ASHLAND DAM

**PHASE I INSPECTION REPORT
NATIONAL DAM INSPECTION PROGRAM**

ASHLAND DAM
SCHUYLKILL COUNTY, PENNSYLVANIA
NATIONAL I.D. NO. PA 00659-
671

PHASE I INSPECTION REPORT
NATIONAL DAM INSPECTION PROGRAM
ASHLAND RESERVOIR
NATIONAL I.D. #PA 00659 671
DER I.D. #54-75

SEEPAGE LOCATION PLAN
ASHLAND DAM

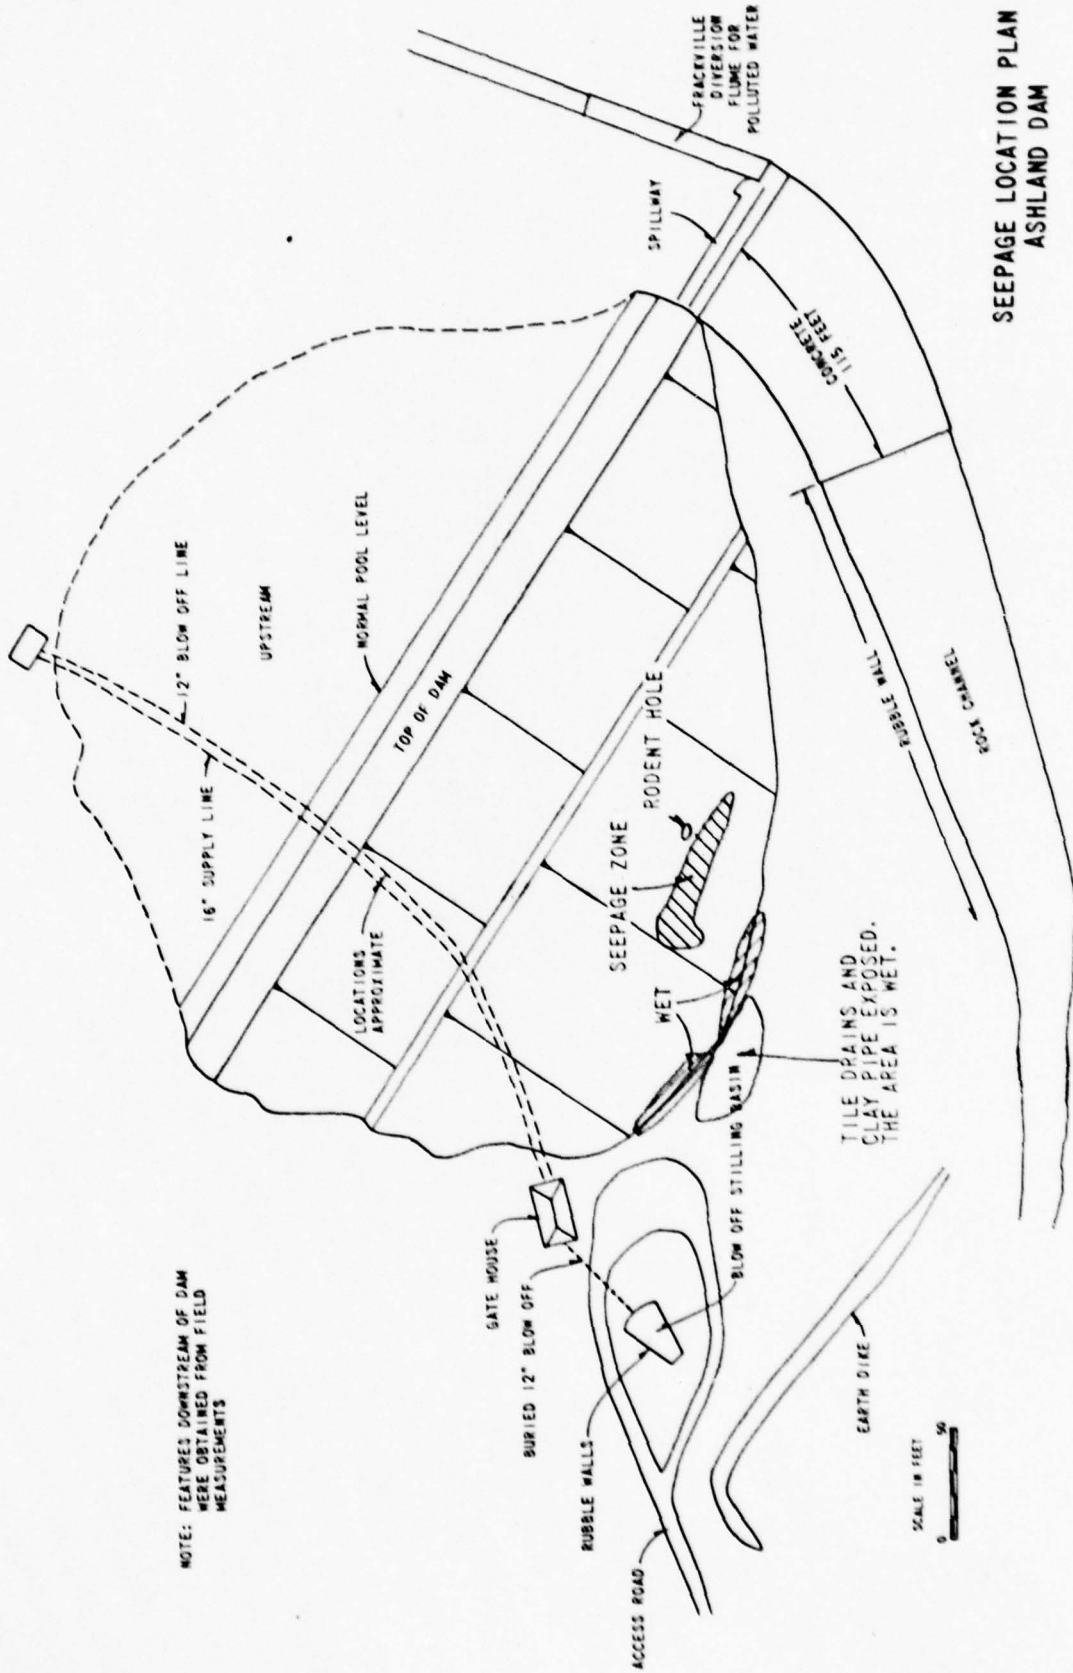
5. The rodent hole noted as shown on Sheet 5a, Appendix B should be filled.

Yes. Seepage was noted through the embankment approximately one third up the slope from the toe towards the left side of the embankment. This same seepage was noted in a photograph dated 5/16/39 by E.F. Langan. Seepage was emanating as sheet flow. A seepage rate could not be determined. See sheet 5a.

Yes. Tile drains are functioning but seepage is collecting over the tiles at the toe of the left abutment. See sheet 5a and photographs in Appendix D.
